UNITED STATES NUCLEAR REGULATORY COMMISSION

In the Matter of	:	
	:	Docket Nos. 50-277
PHILADELPHIA ELECTRIC COMPANY	:	50-278

APPLICATION FOR AMENDMENT
OF
FACILITY OPERATING LICENSES
DPR-44 & DPR-56

APPLICATION FOR AMENDMENT
OF
FACILITY OPERATING LICENSES
DPR-44 & DPR-56

POOR ORIGINAL

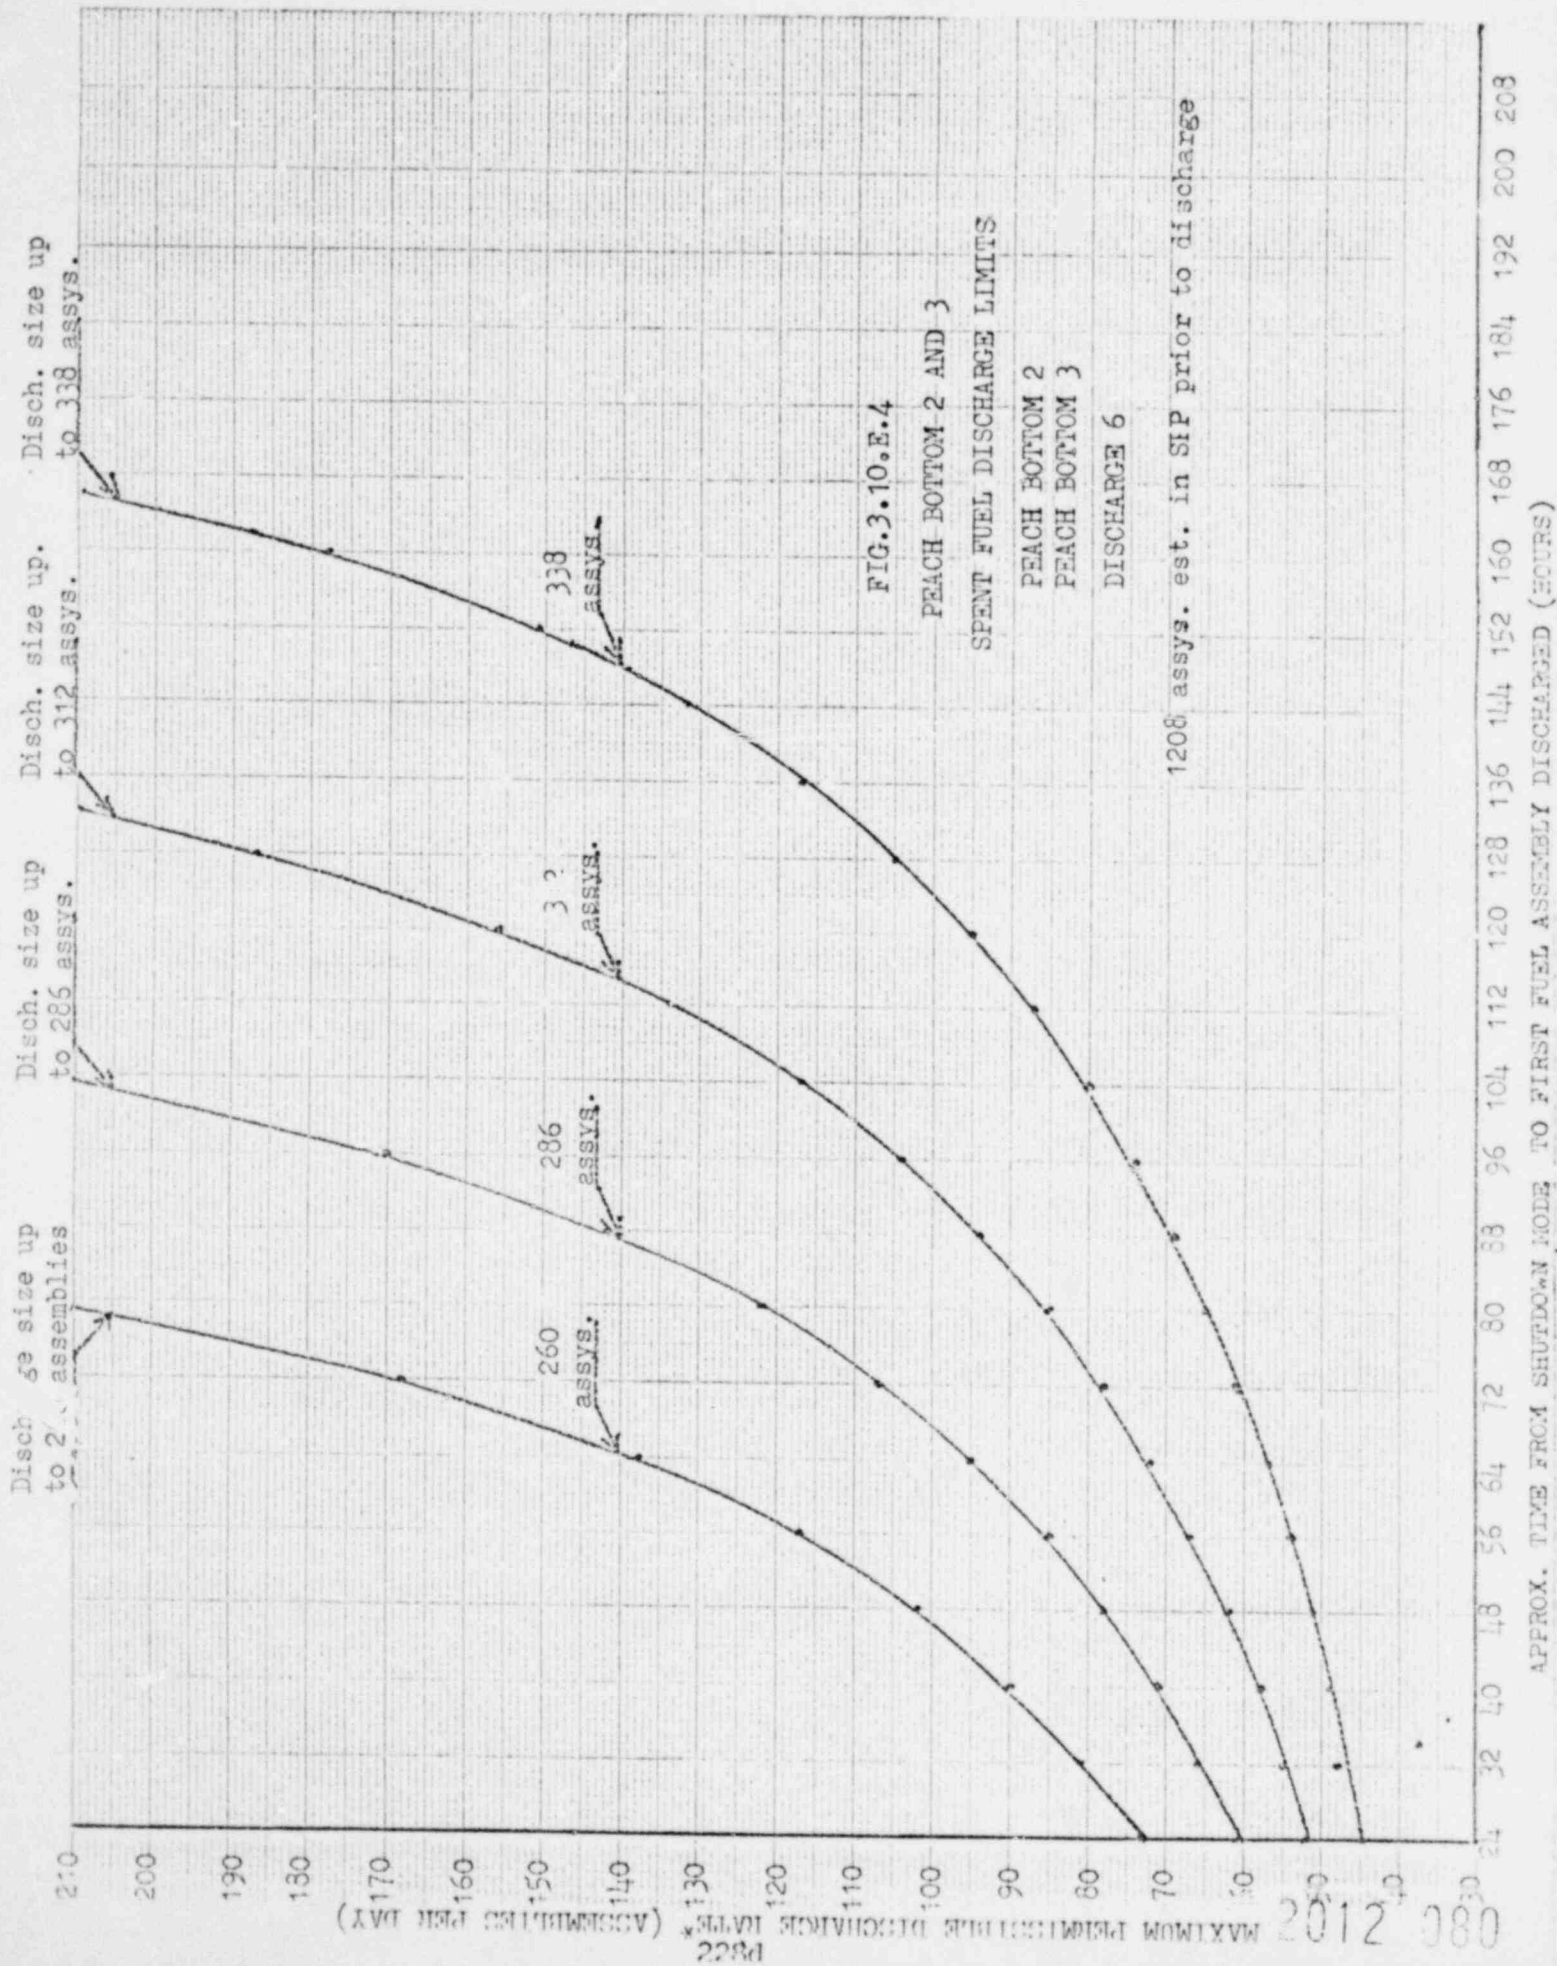
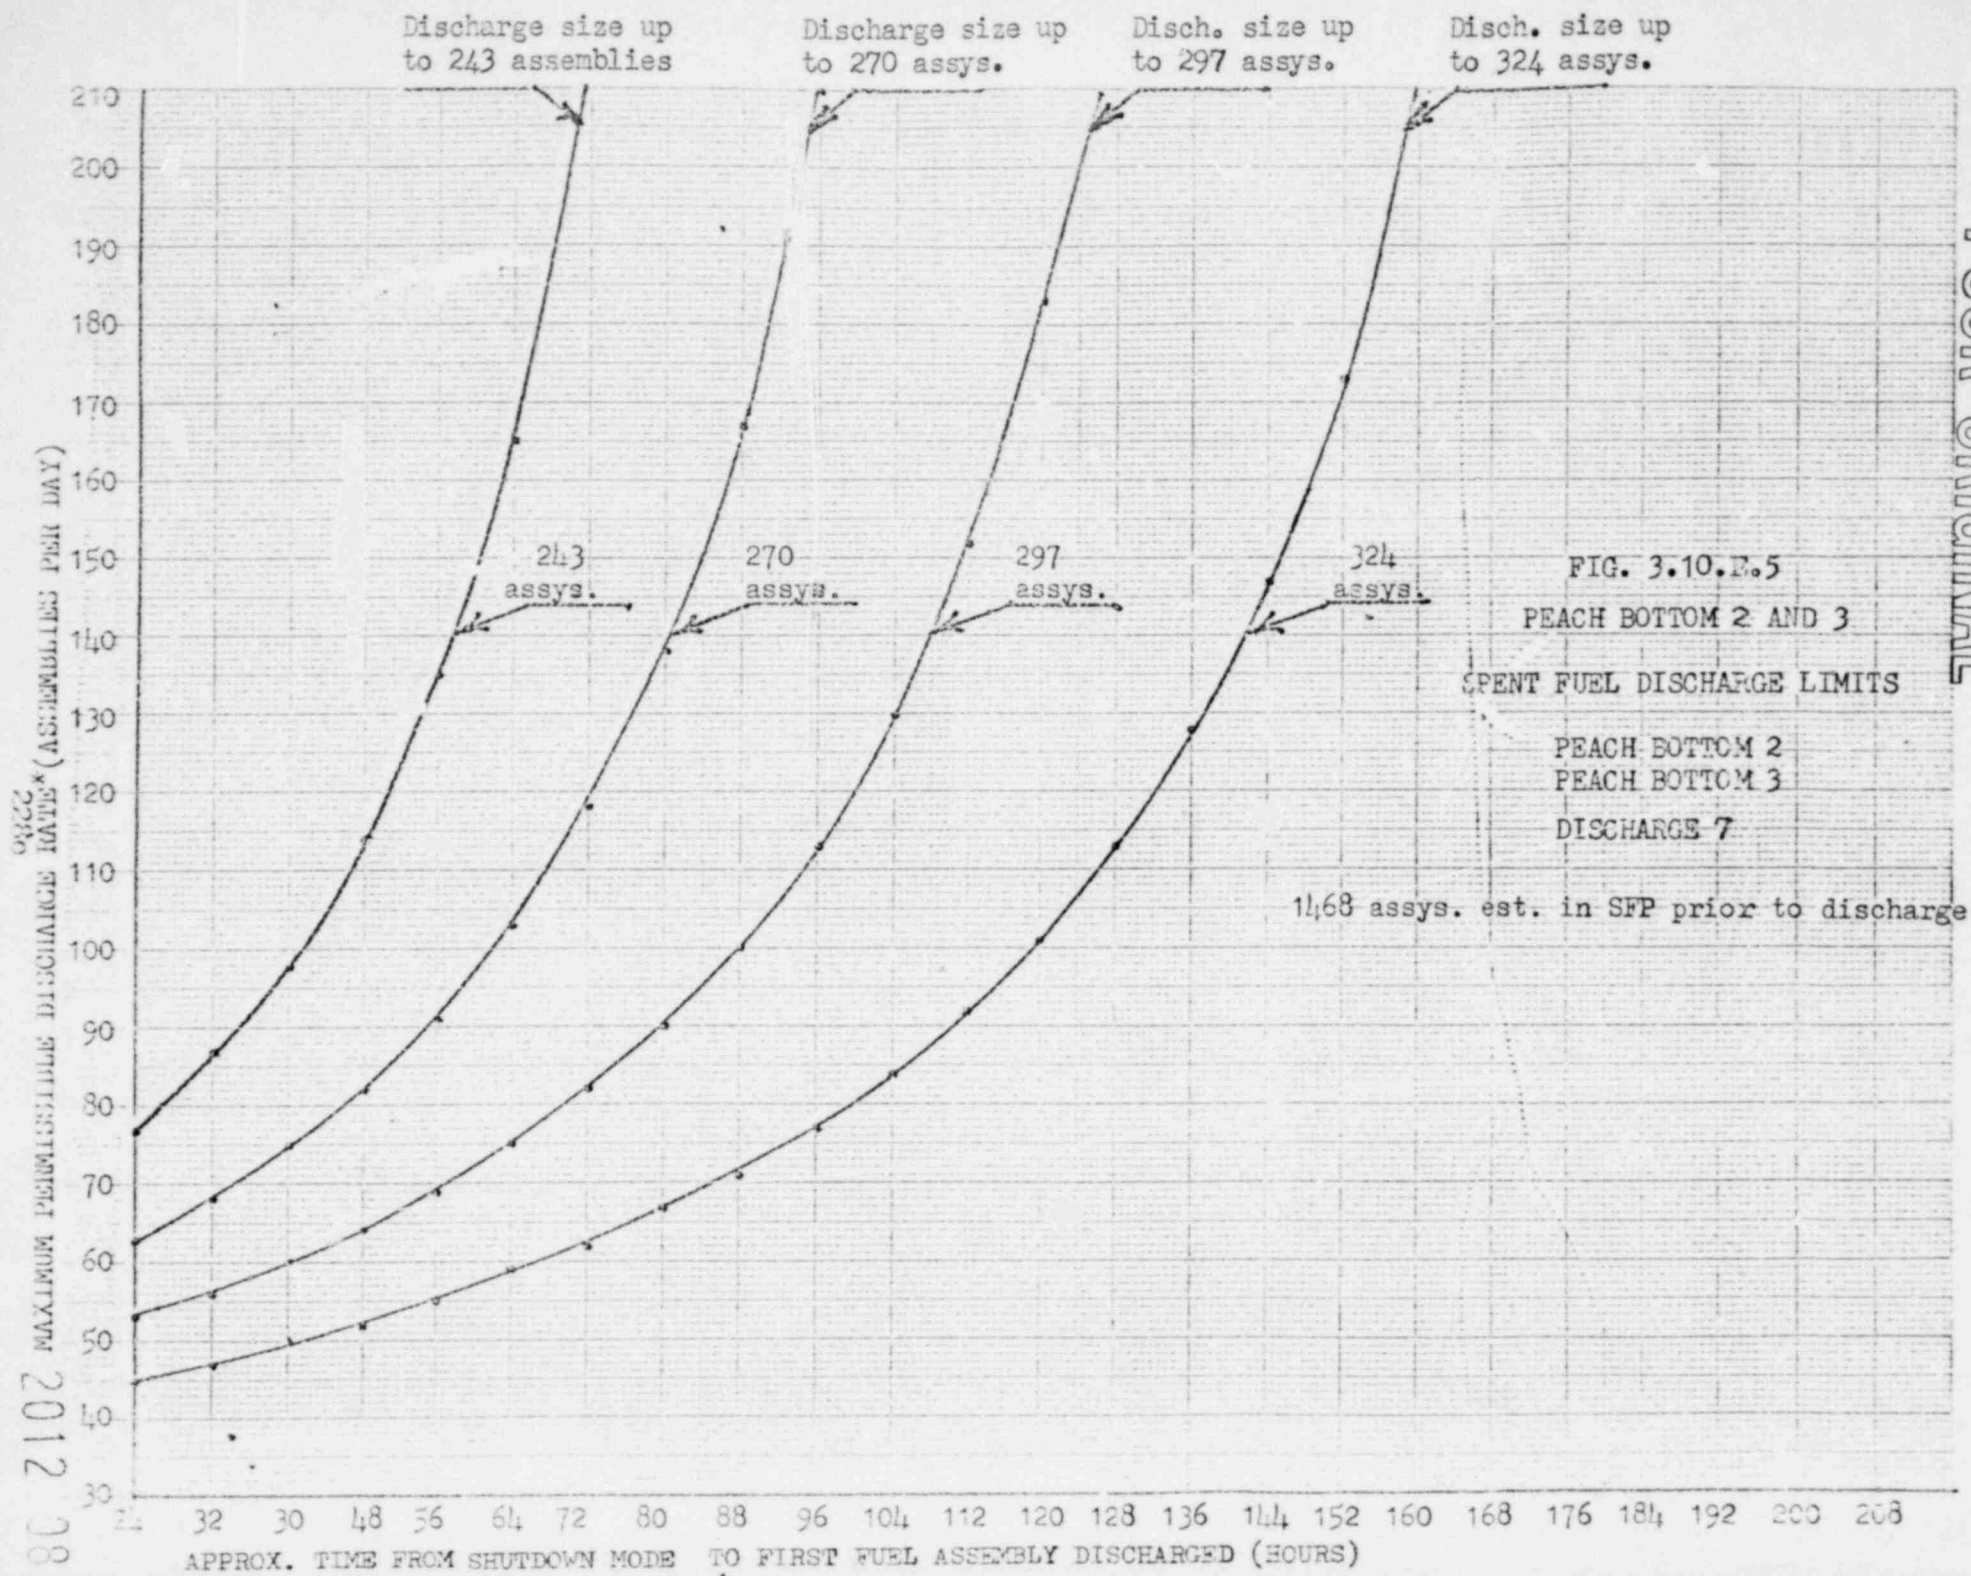
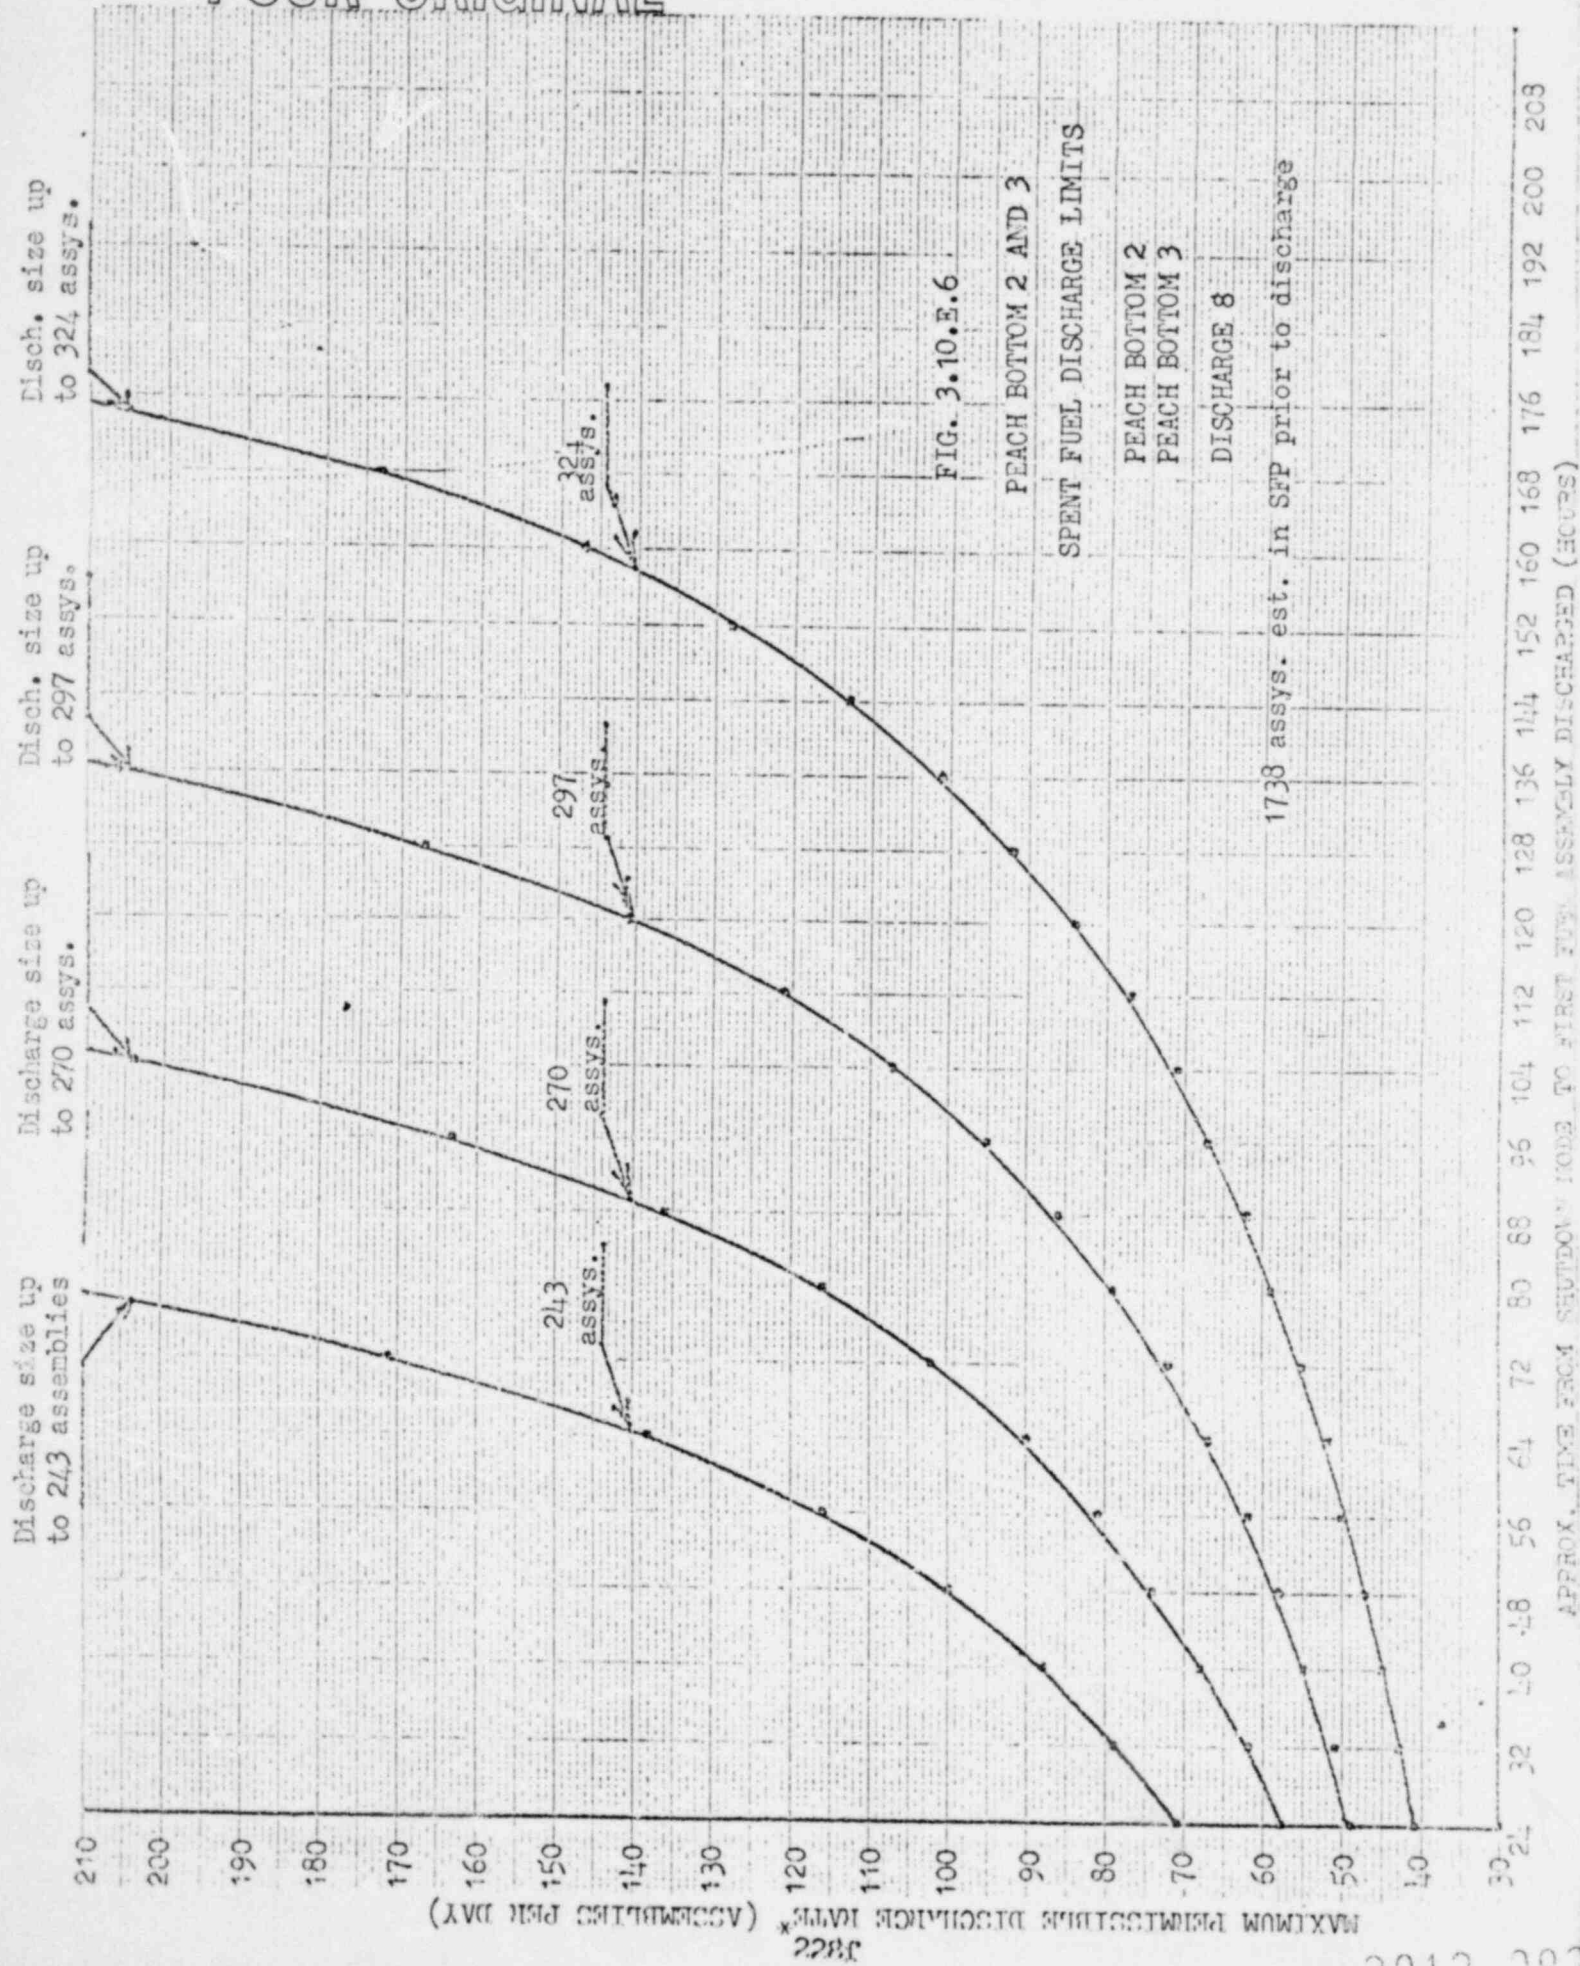
The Licensee proposes revisions to Technical Specification, section 3.10.E, that change the limiting conditions for the discharge of spent fuel from the reactor vessel to the Spent Fuel Pool. The revised limits would permit a spent fuel discharge rate based on the elapsed time following the reactor shutdown, the quantity of fuel to be discharged, river water temperature, and the discharge cycle (number). A description of the safety analysis is included in section 3.10.E BASES on page 230a. The safety analysis, using data and assumptions previously submitted on January 19, 1978, in support of the installation of high density racks in the Peach Bottom spent fuel pools, was performed to develop the maximum permissible discharge rates shown in the proposed figures 3.10.E.1 through 9.

In order to maintain SFP temperature less than or equal to 150°F, the rate of discharge of spent fuel assemblies from the reactor to the spent fuel pool shall not exceed the maximum permissible discharge rate obtained from Figures 3.10.E.1 through 9, whenever the spent fuel pool cooling system is in use. No limitations are required whenever the Residual Heat Removal System is arranged for spent fuel pool cooling.

- 1) Using the discharge (cycle) number, select the corresponding figure from Figures 3.10.E.1 through 9.
 - 2) Select the one curve (of the four in the figure selected in item 1 above) which corresponds to the discharge size next highest to (or equal to) the total number of assemblies to be moved to the SFP during the outage.

- 3) Using the time from reactor shutdown to first fuel assembly discharged (ordinate) which is achieved during the outage, read the coordinate maximum permissible discharge rate* from the curve selected in item 2) above. This maximum permissible discharge rate shall be used as a limit during the outage, in order to maintain SFP temperature less than or equal to 150°F.

- 4) If it is desired to correct the maximum permissible discharge rate for cooling (river) water temperatures, determine the river water temperature at time of first discharge and every 24 hours thereafter. Using the appropriate correction factor, multiply the maximum permissible discharge rate obtained in item (3) above by the correction factor for that 24 hour period. The corrected maximum permissible discharge rate shall be used as a limit during the corresponding 24 hour segment of the outage. Correction factors are as follows:

- a) 71°F - 80°F cooling water: 1.5
 - b) 61°F - 70°F: 2.5
 - c) 60°F or lower: 4.0
 - 5) The maximum permissible rate operates cumulatively; that is, if the permissible rate for a particular discharge is 100 assemblies per day and only 50 assemblies are discharged the first day, then 150 may be discharged the second day.
